**ADDENDUM NO. 1****08/09/2022**

**RE: Paintsville Pool Renovation  
Paintsville, KY  
Project No. 21141**

**FROM: Brandstetter Carroll Inc.  
2360 Chauvin Drive  
Lexington, Kentucky 40517  
Phone 859-268-1933  
Fax 859-268-3341**

**C1** Section Thru Building  
1/2"=1'-0"

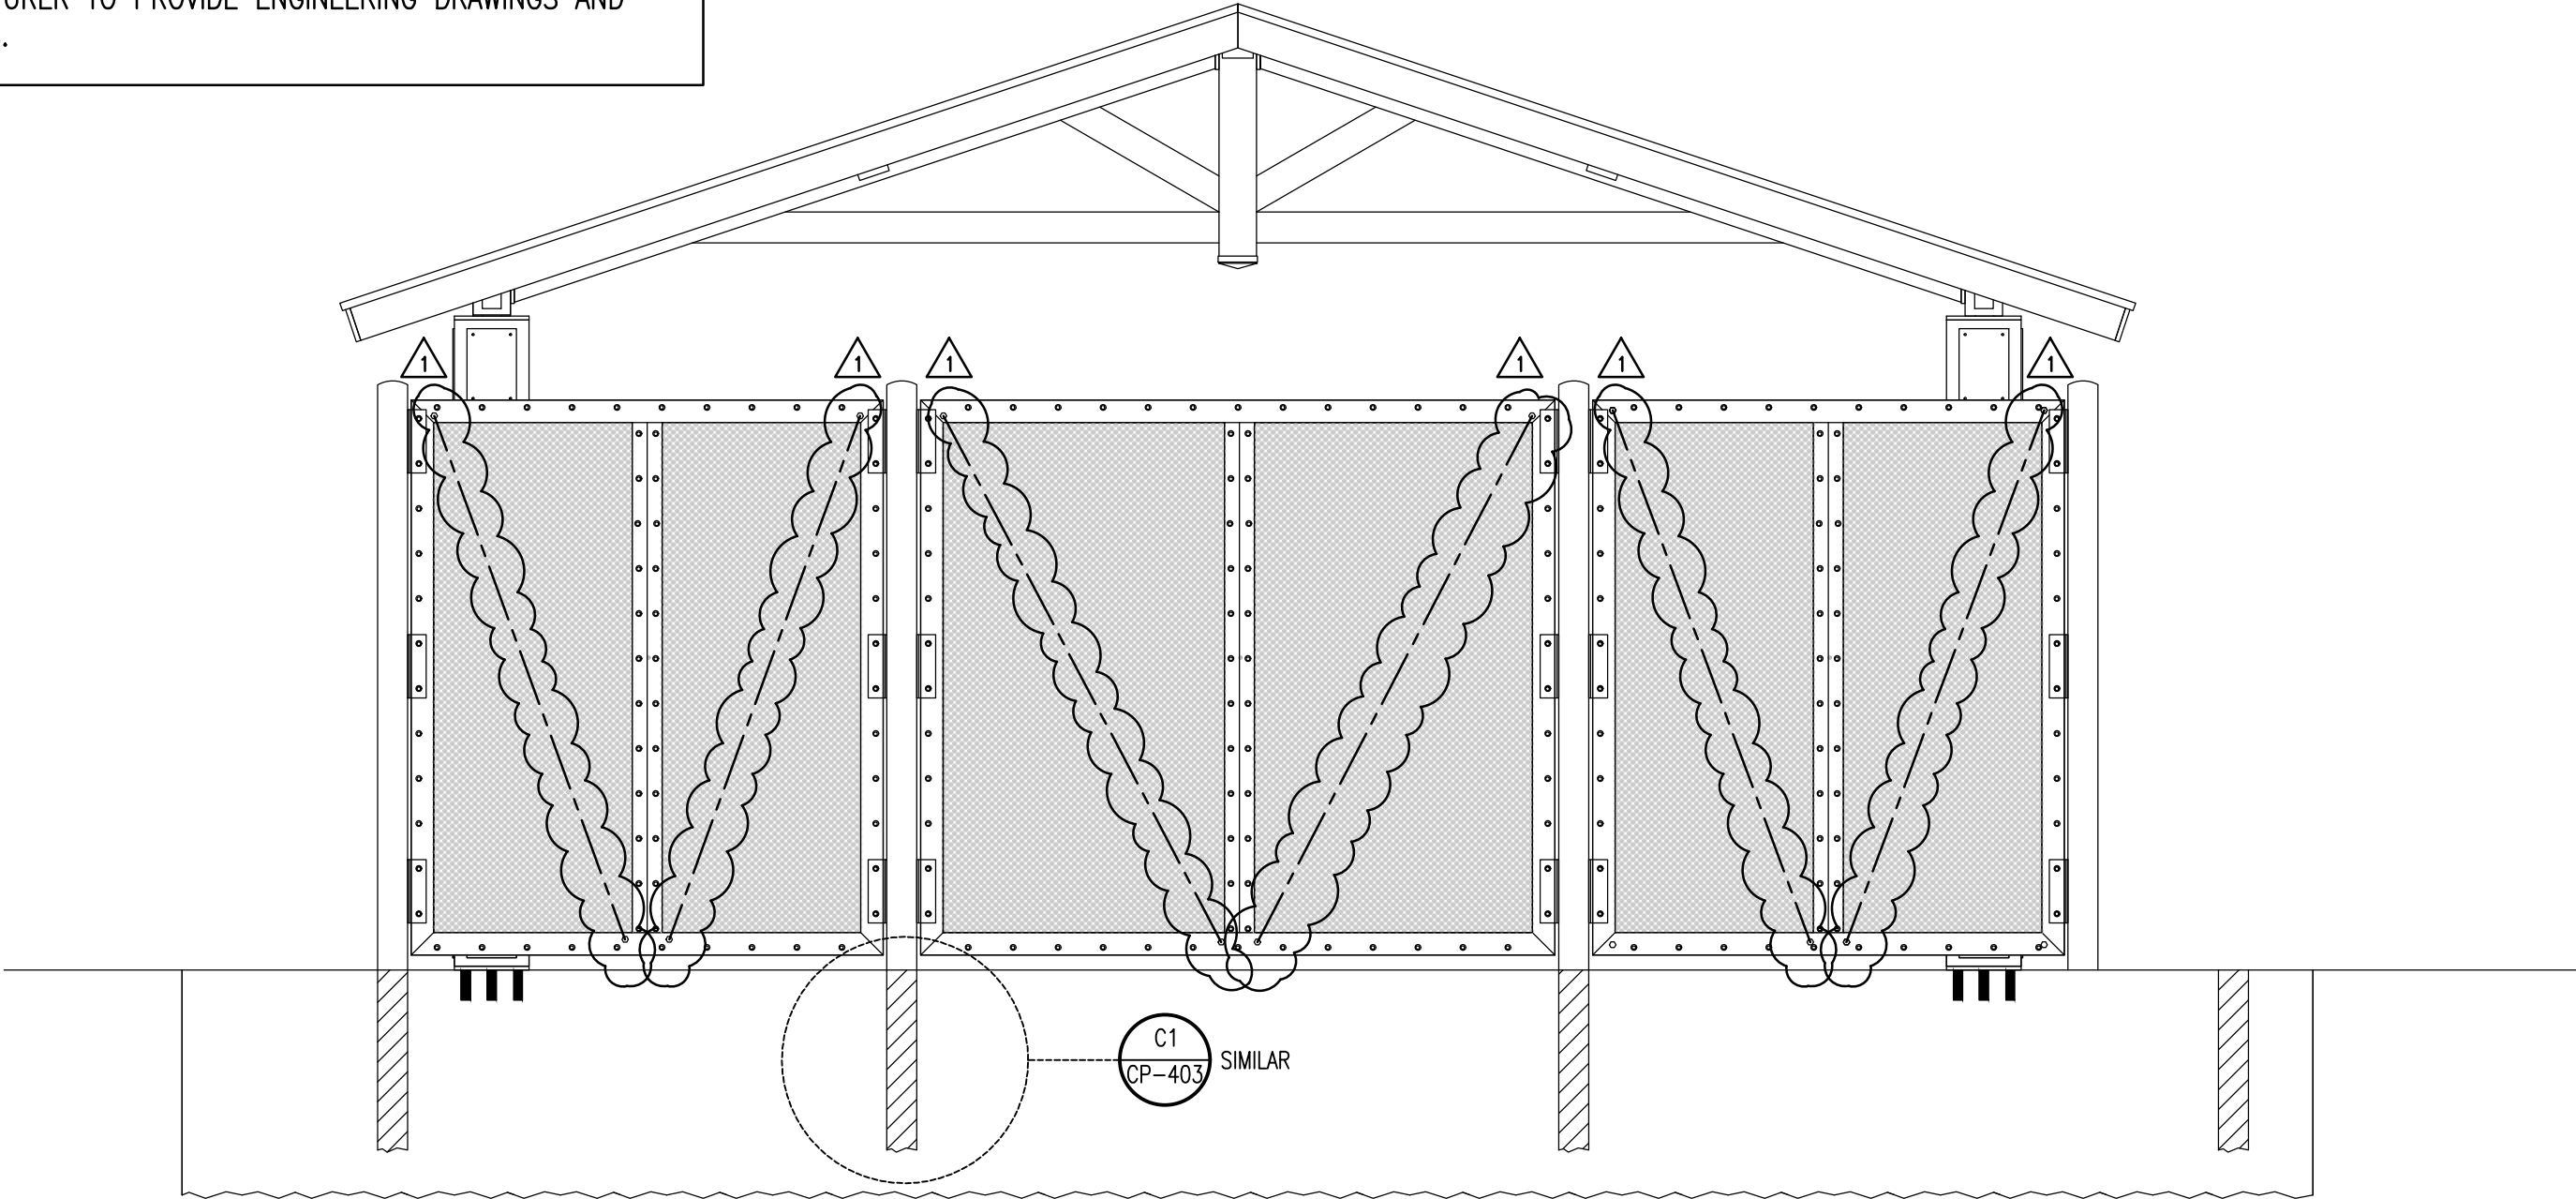
1. CP-403 – Filter Building Structural & Architectural
  - A. Detail C2 - Added powder coated angle braces behind perforated panels to detail
2. CP-404 – Filter Building Elevations
  - A. Detail C1 - Added powder coated angle braces behind perforated panels.
